APPENDIX C – PlanGrid Task Report

PlanGrid Task Report - Aug 19, 2020

Prepared by James Holtom

#59 Architectural

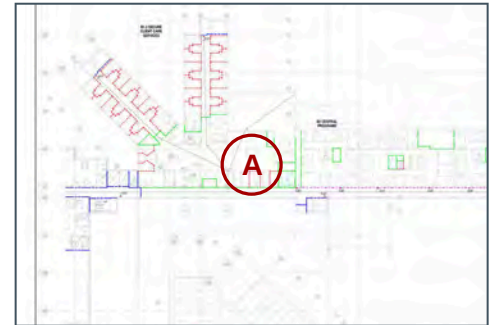
Fire rating penetrations may not all be fire caulked to meet smoke separation requirements

#182 Architectural

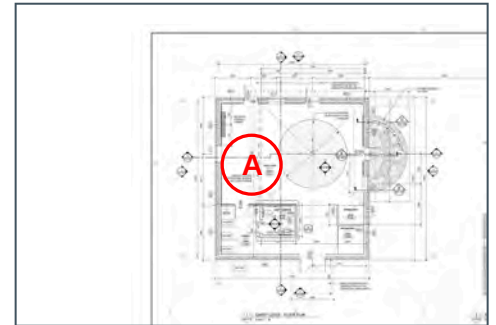
Sweat lodge. No flooring, being done by MCS. Is this tracked as a change or an original requirement? Concern on door thresholds to be flush with new flooring.

#380 Architectural

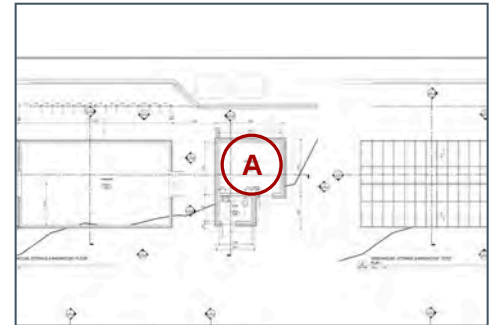
Not constructed, storage shed constructed in place. Confirm if approved change

#460 Architectural

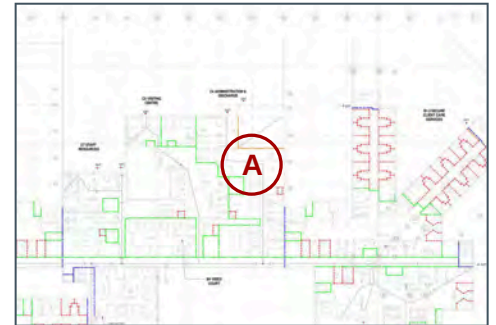
No exit sign here, shown as exit route on plans

#265 Mechanical

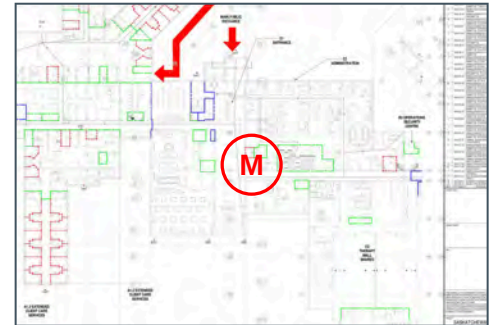
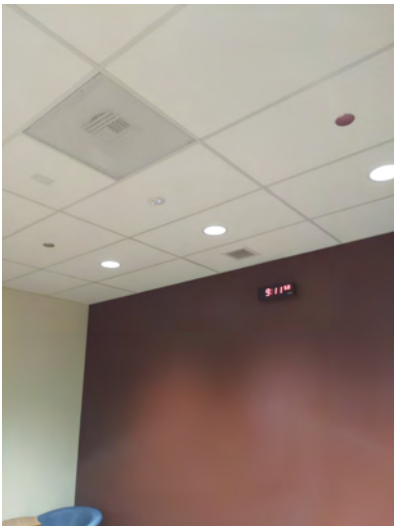
Return grille loud. Supply diffuser different style than typical for client area.
